RE: DEQ Comments on Phase III PFAS Work Plan
Portland Air National Guard
ECSI# 1372

Oregon DEQ staff completed review of the *Work Plan for Fiscal Year 2017 Phase III, Regional Site Inspection for Perfluorooctanesulfonate and Perfluorooctanoic Acid at Portland Air National Guard Base, Portland, Oregon*. The work plan was prepared by Leidos for the Air National Guard, Restoration Branch and dated January 2018.

Re: Review Comments
Site Inspection Work Plan for PFOS and PFOA (Draft Final)
Portland Air National Guard
February 2018

Draft Final Portland Site Inspection Work Plan (SI WP) for Perfluorinated Compounds (PFCs) Phase III
Portland Air National Guard Base, Portland, Oregon
January 2018

PROPOSED SAMPLE LOCATIONS AT
BUILDING 180, HANGAR 290, HANGAR
310, HANGAR 380, HANGAR 375, AND
BASINS (PRL 02, 05, 06, 07, 08, AND 1)

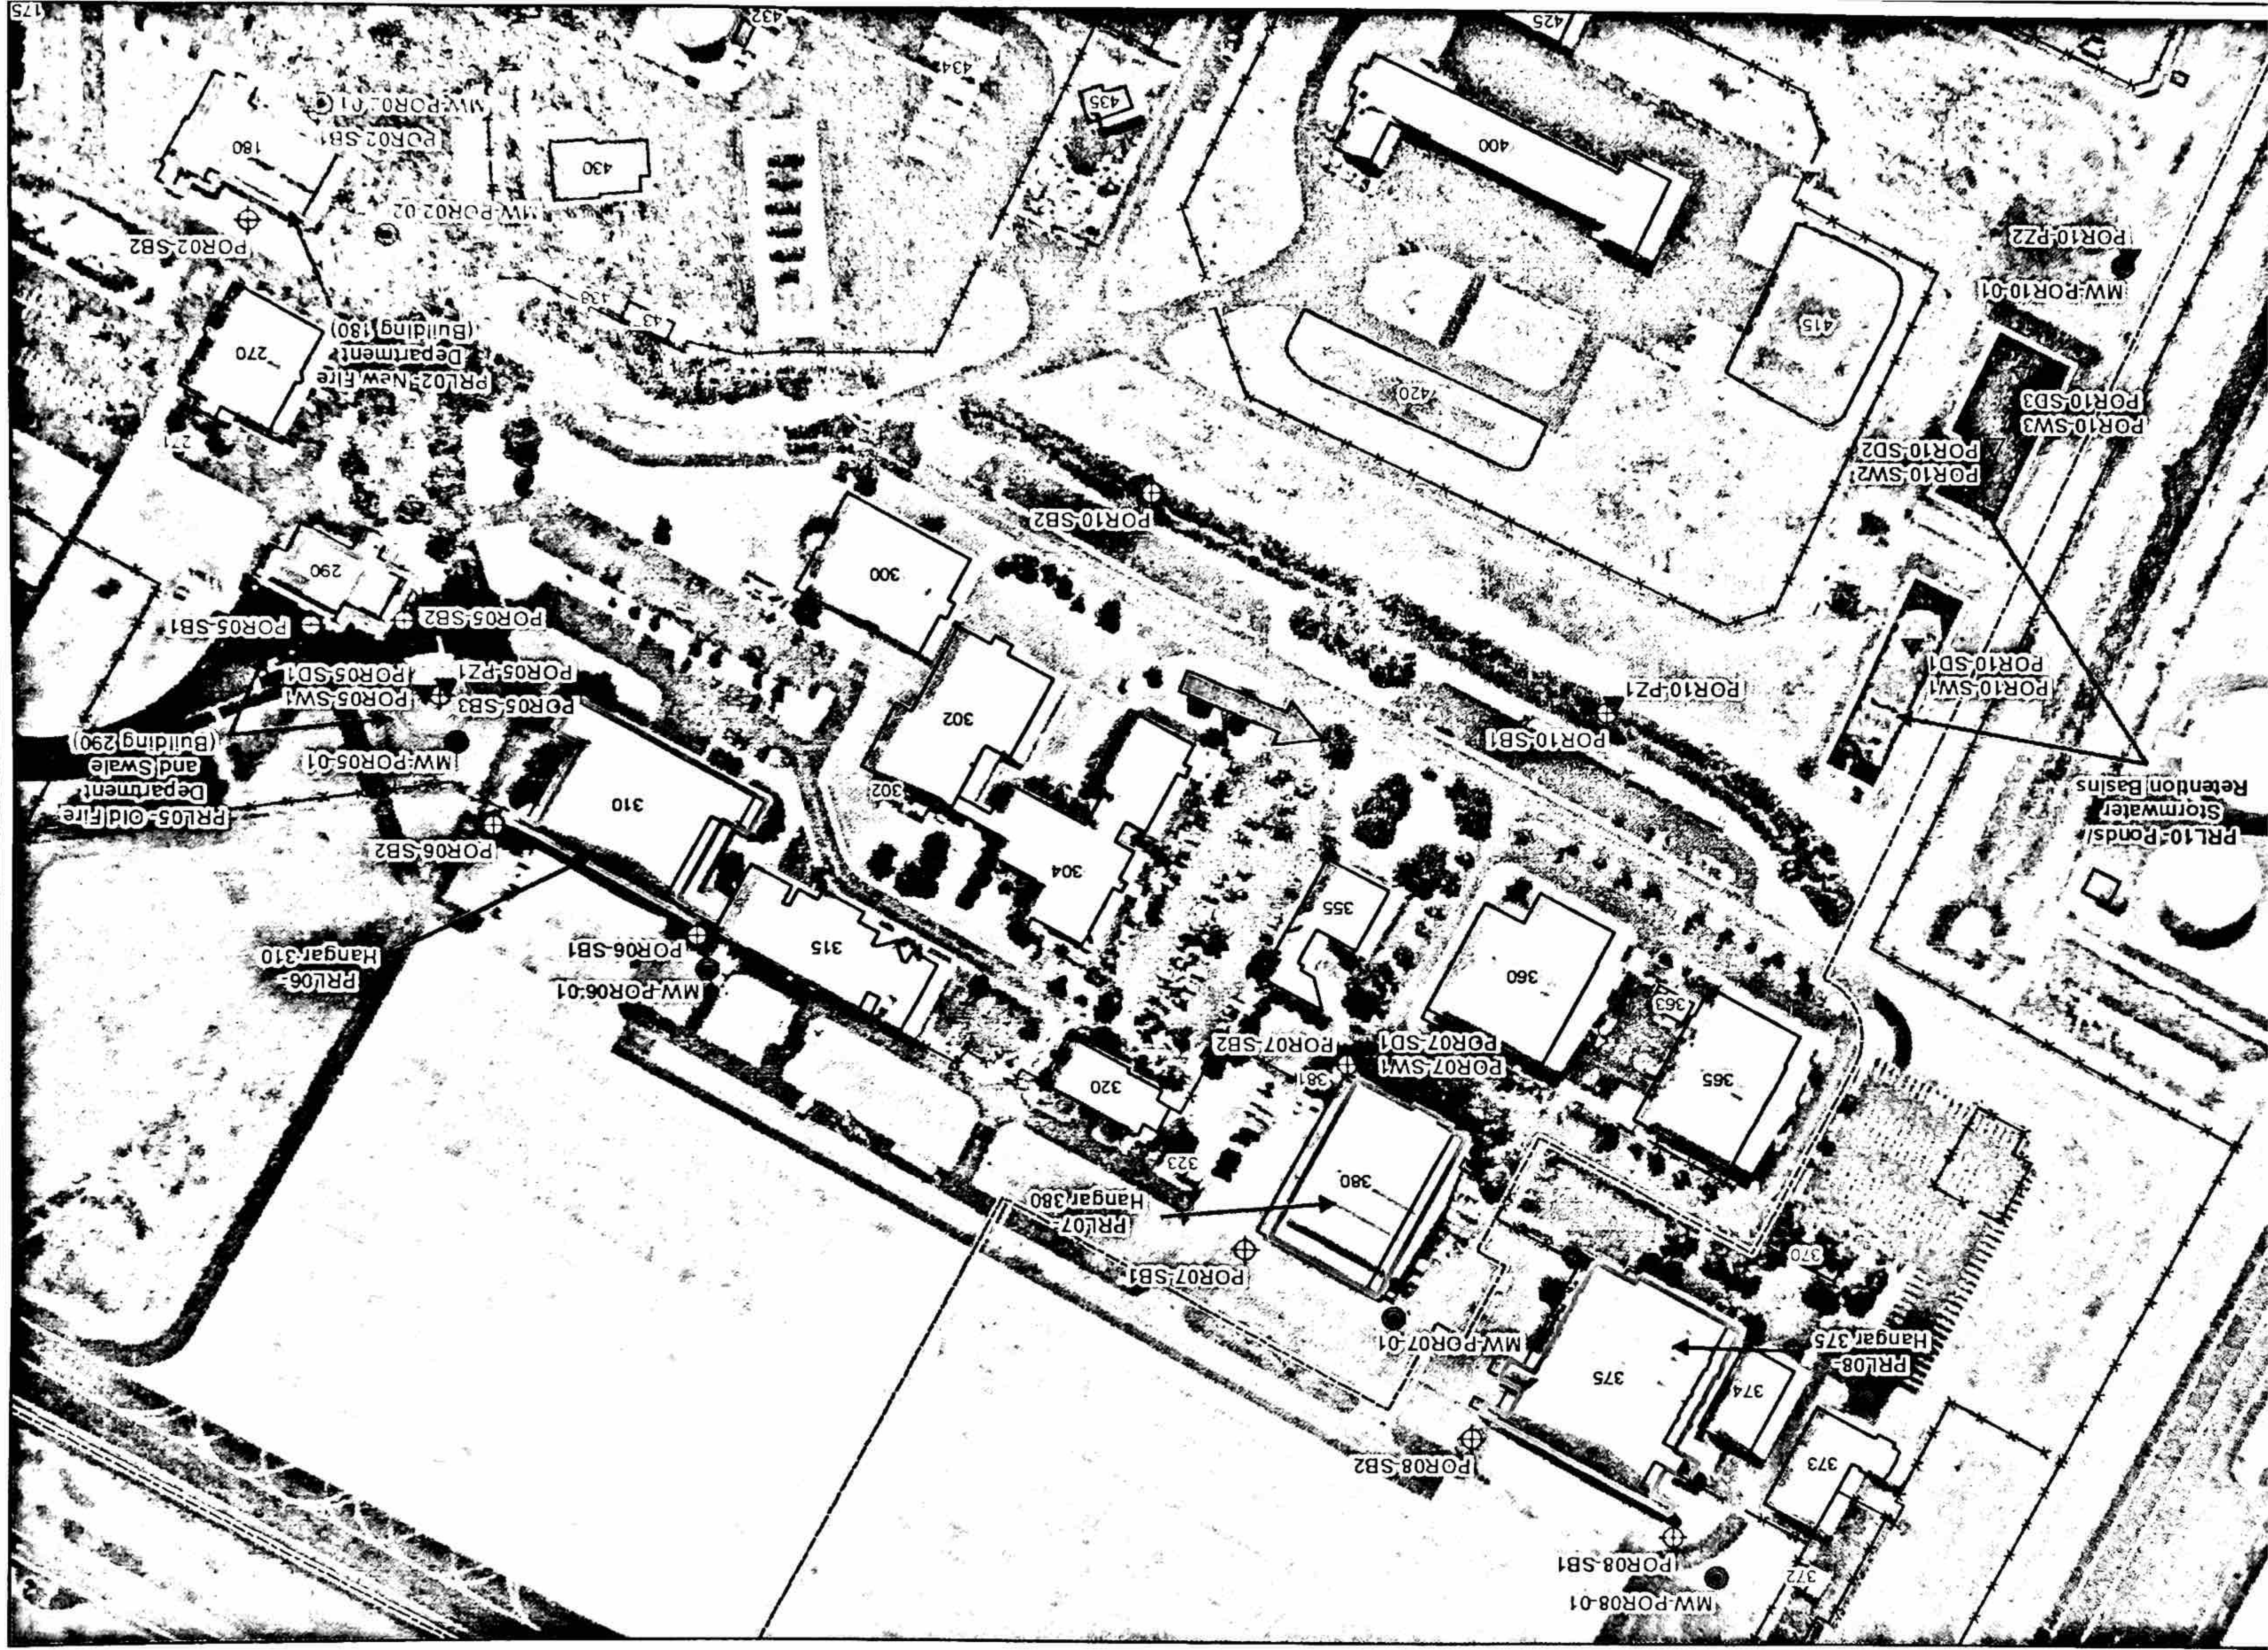
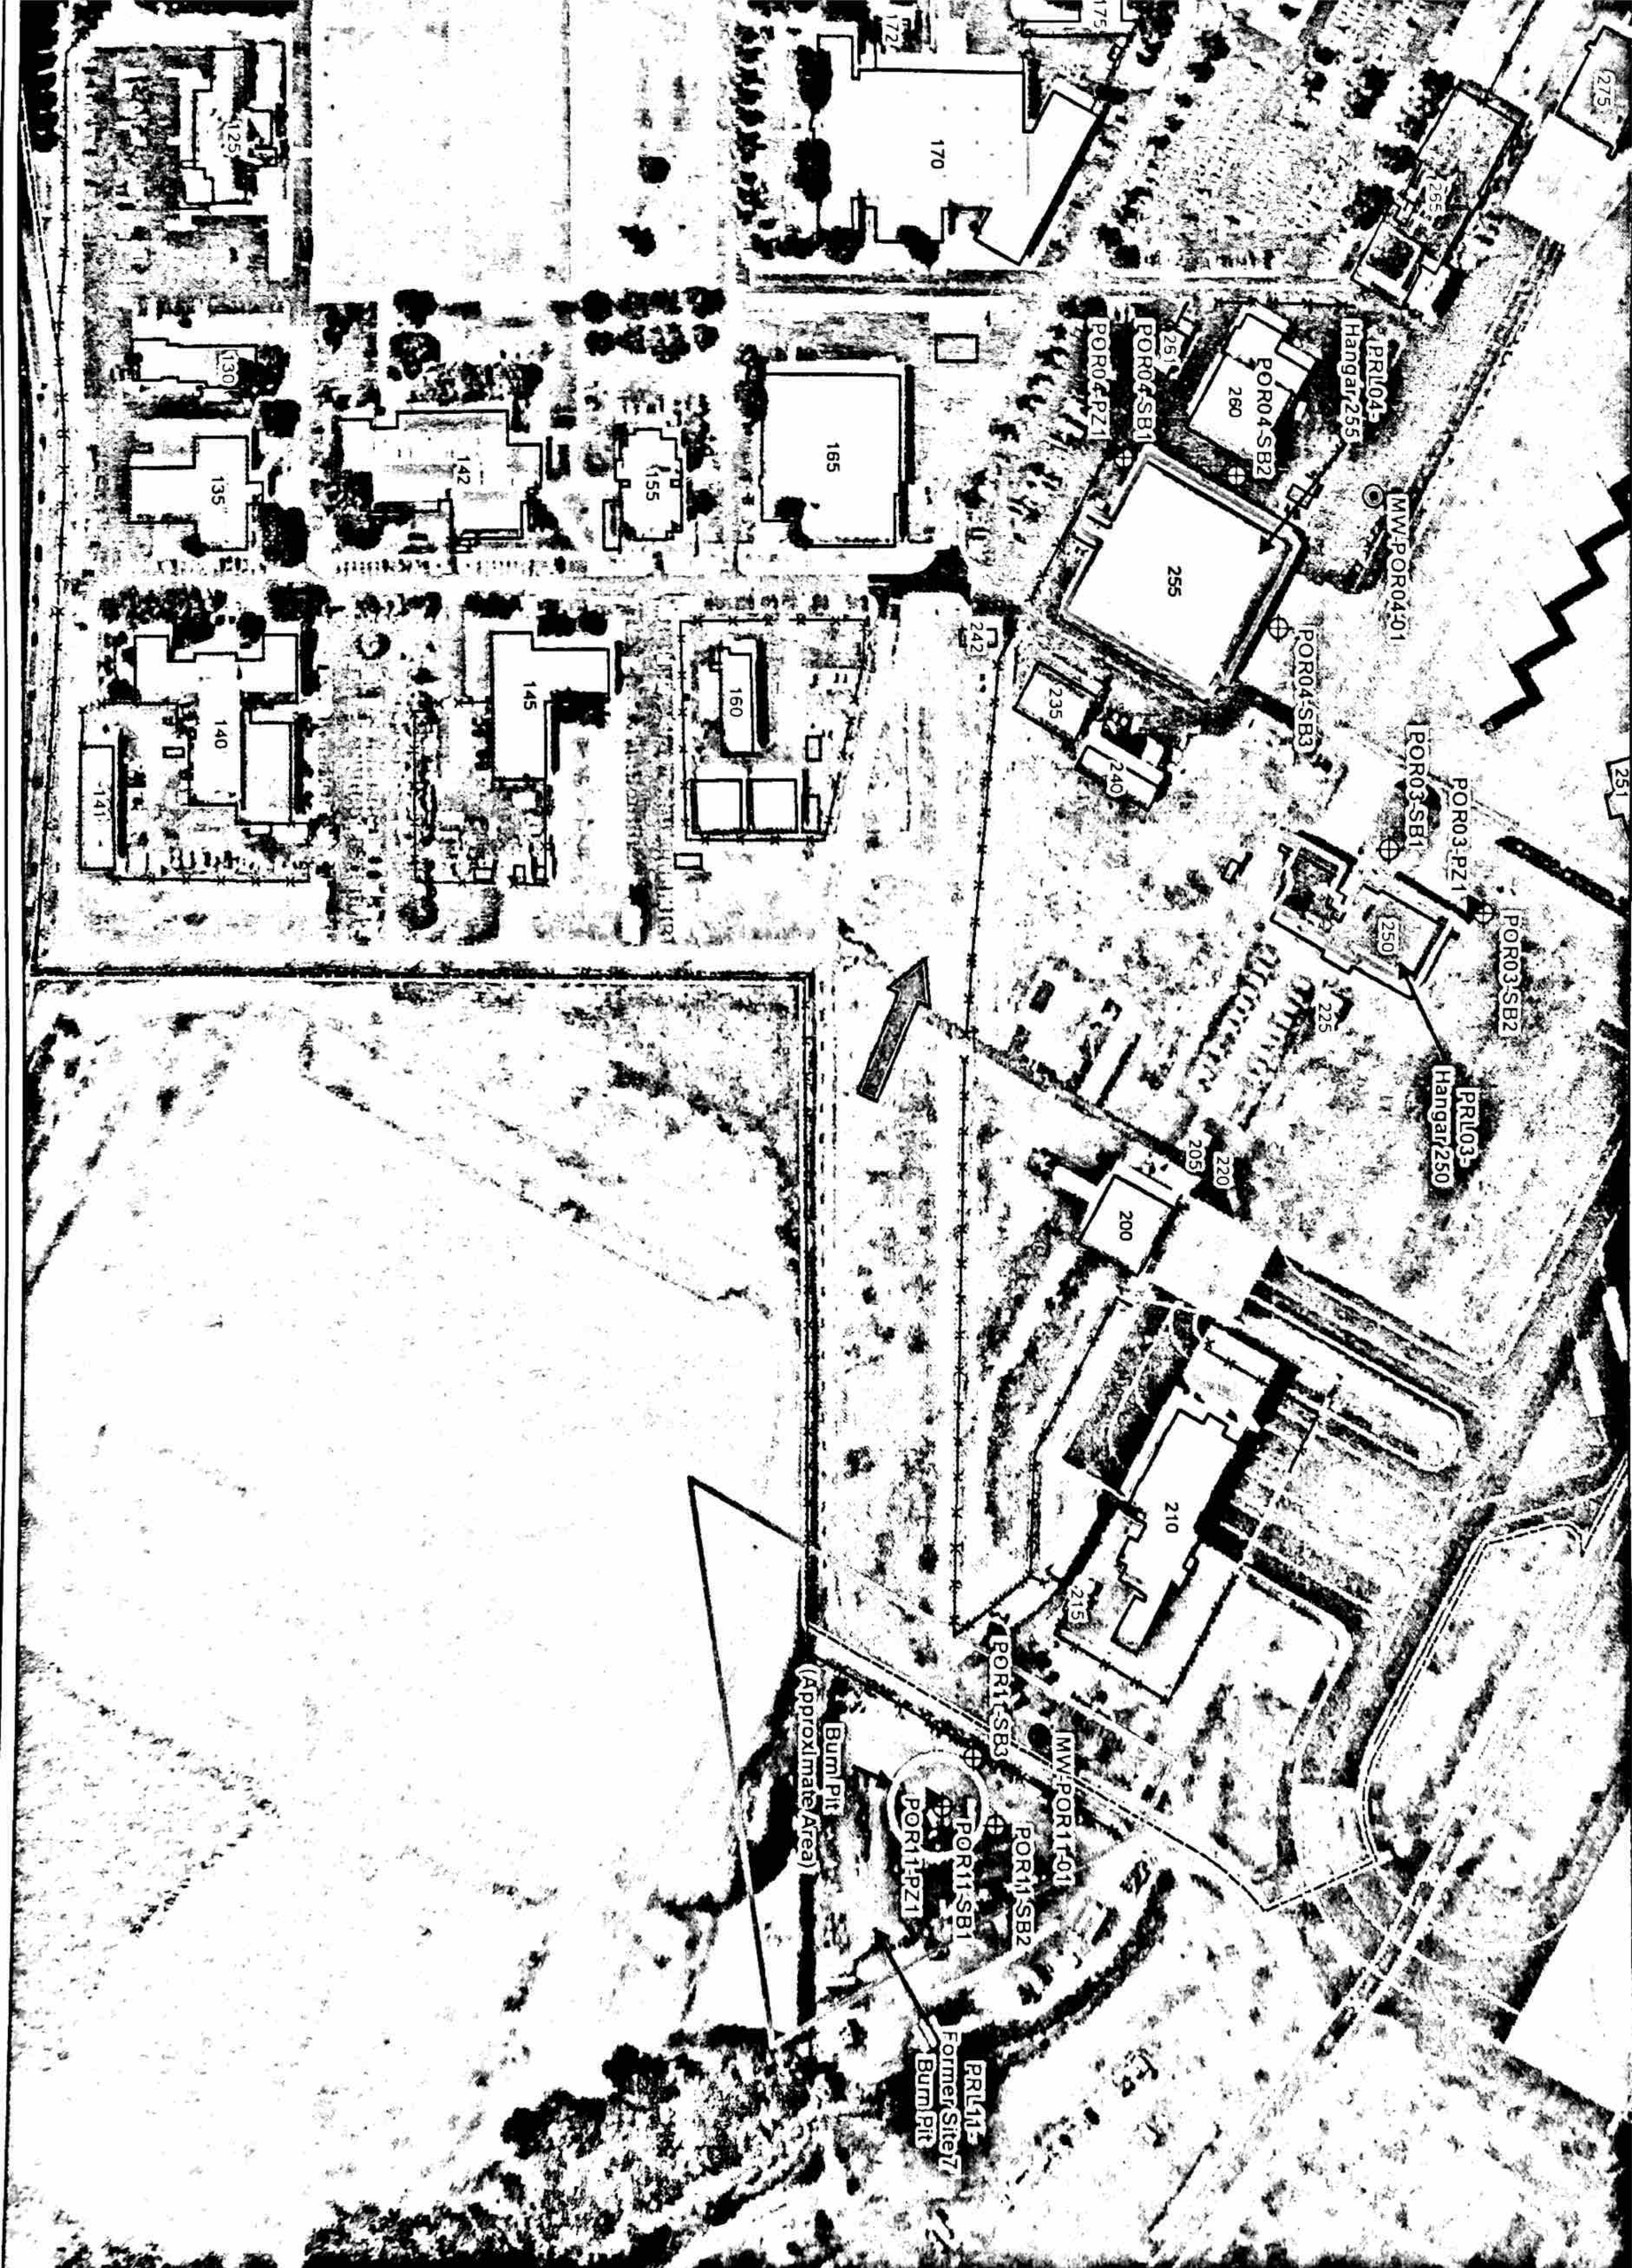
- DEQ's recollection is that during inspection of the New Fire Department Building, Guard staff pointed out a location where there had been a period of drippage from a AFFF line inside the building, and that collection of either a soil or groundwater sample (beneath the building slab) was discussed. We do not see this on Figure 6-1. Could you please clarify?

Response: POR02-SB1 and MW-POR02-01 were intended to evaluate the dripping noted from the AFFF line at the center bay. The permanent well will remain outside the building, however, POR02-SB1 will be relocated to the drip location within the building. This revision will be made in the Final Portland SI Work Plan.
